PROPOSED AMENDMENTS TO SPEED REDUCTION MEASURES ON FERME PARK ROAD

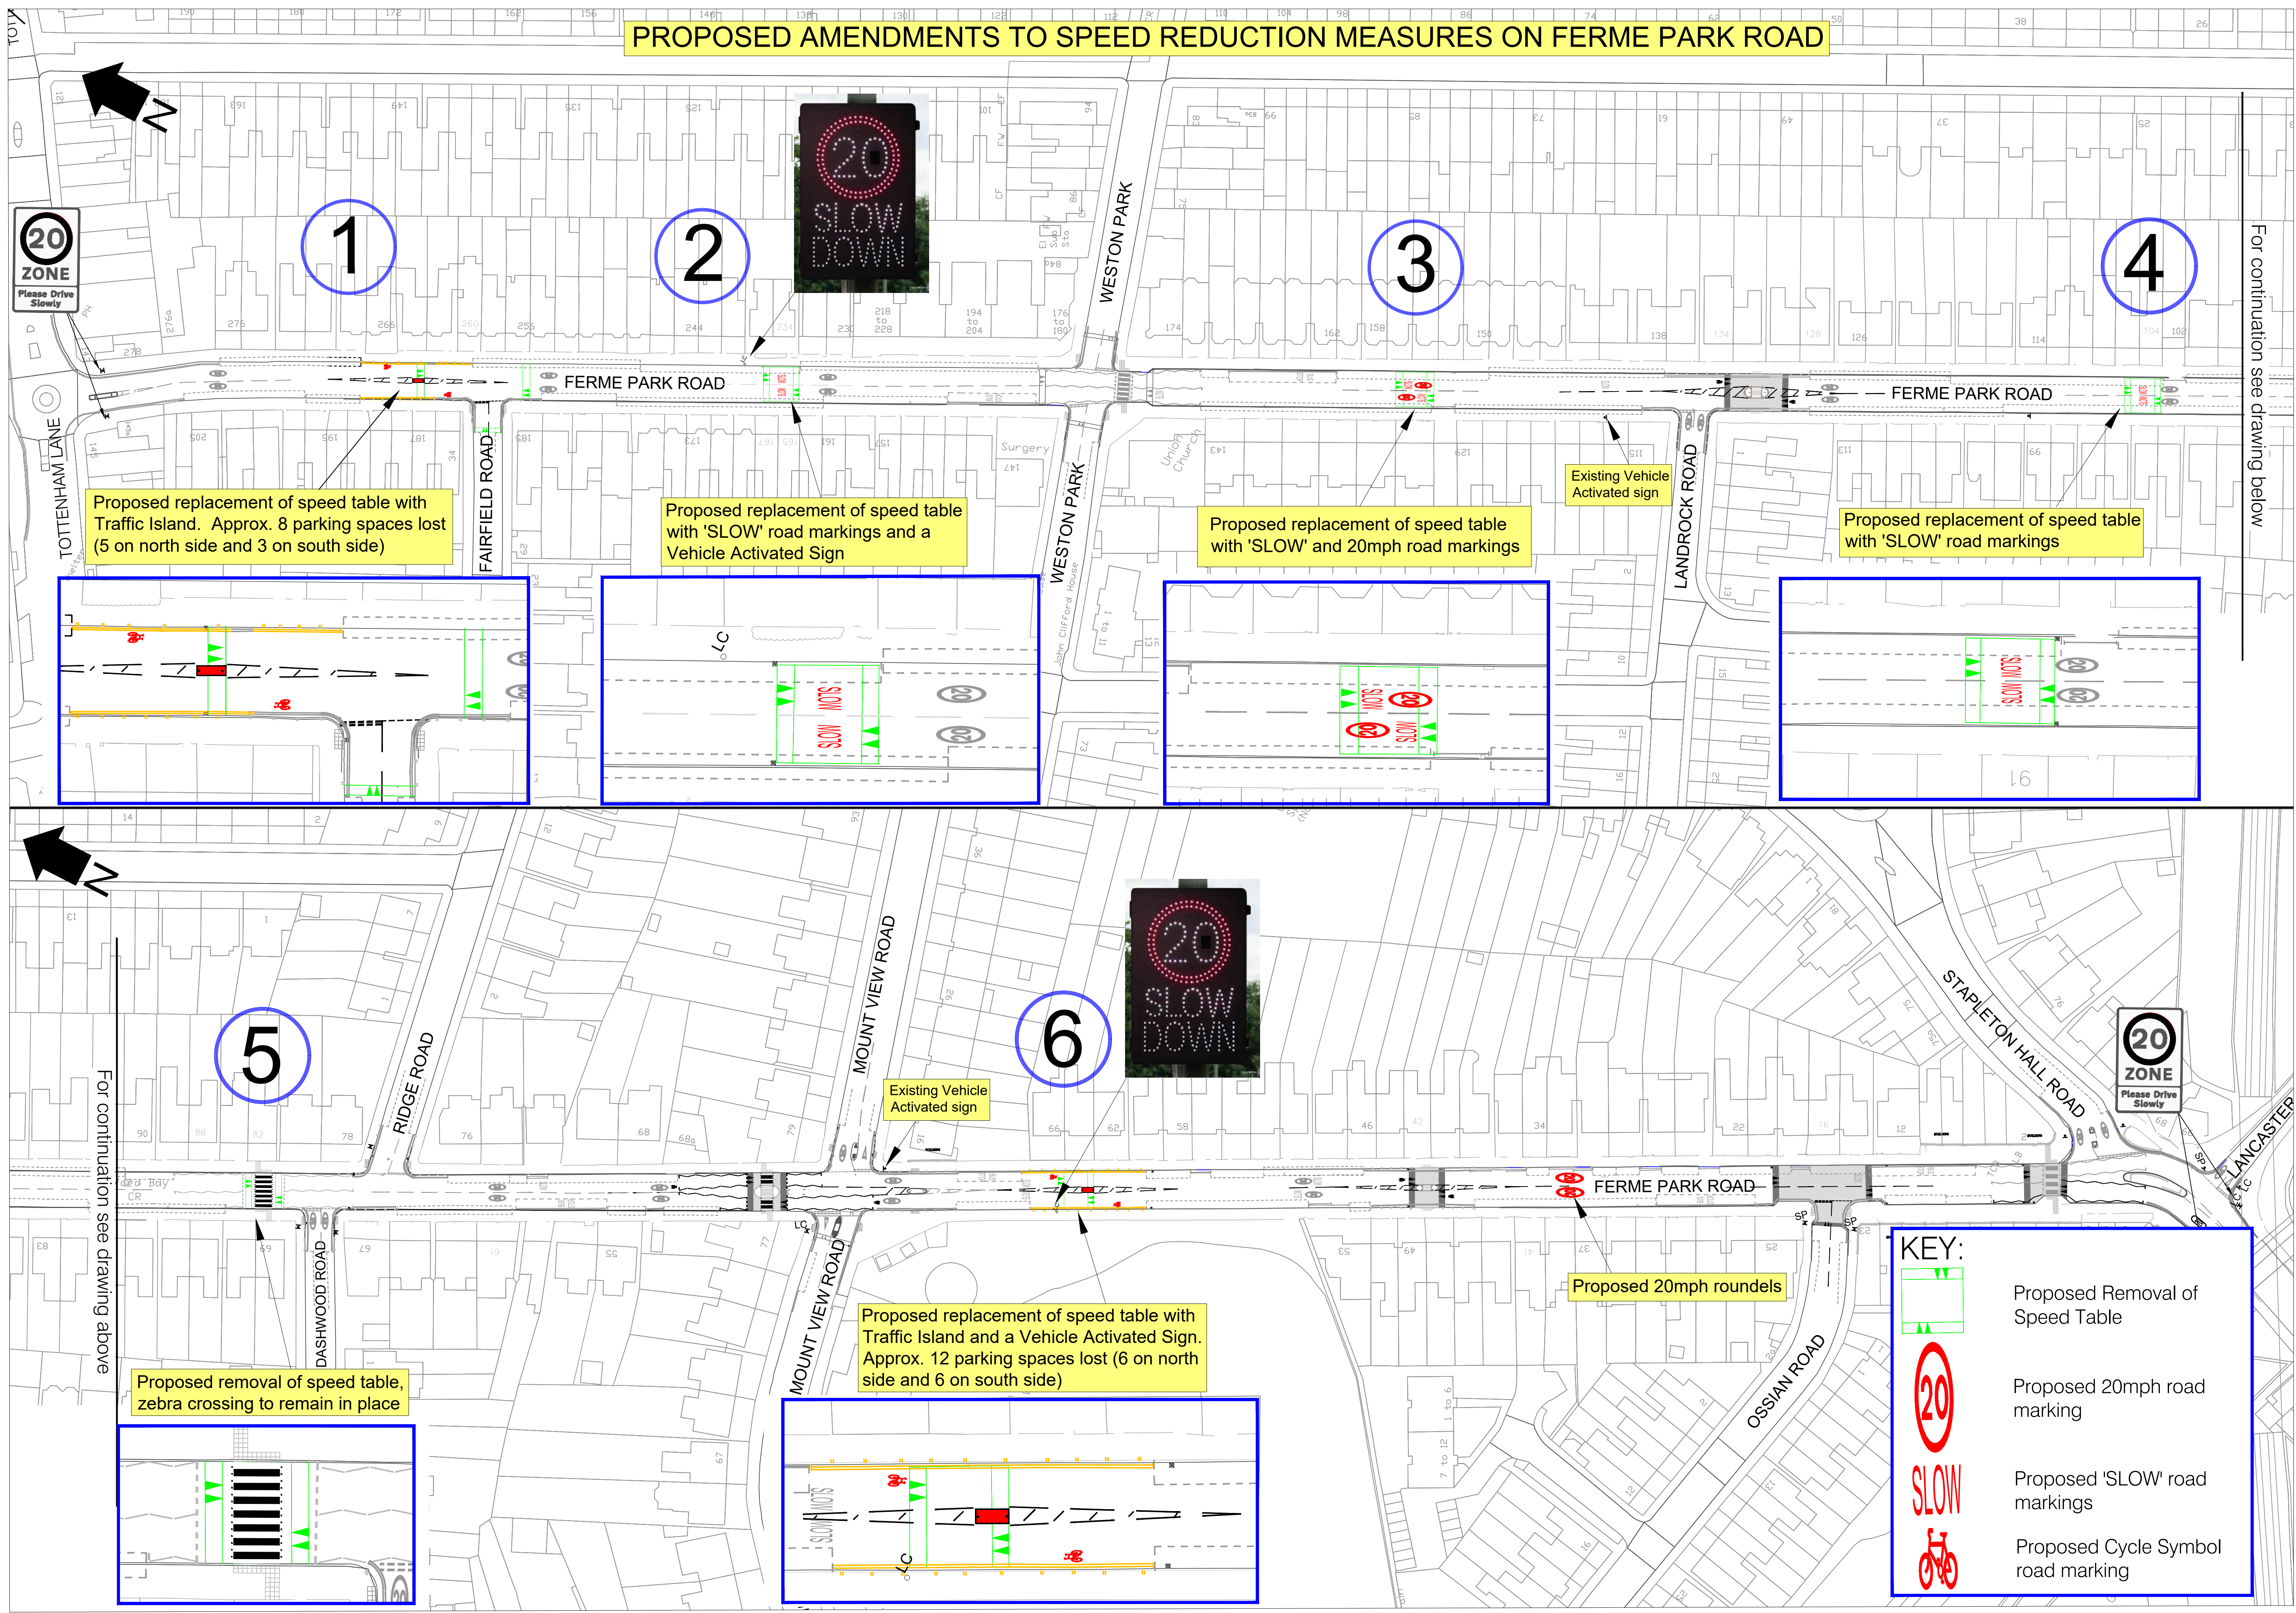
- Proposed Removal of Speed Table
- Proposed 20mph road marking
- Proposed 'SLOW' road markings
- Proposed Cycle Symbol road marking
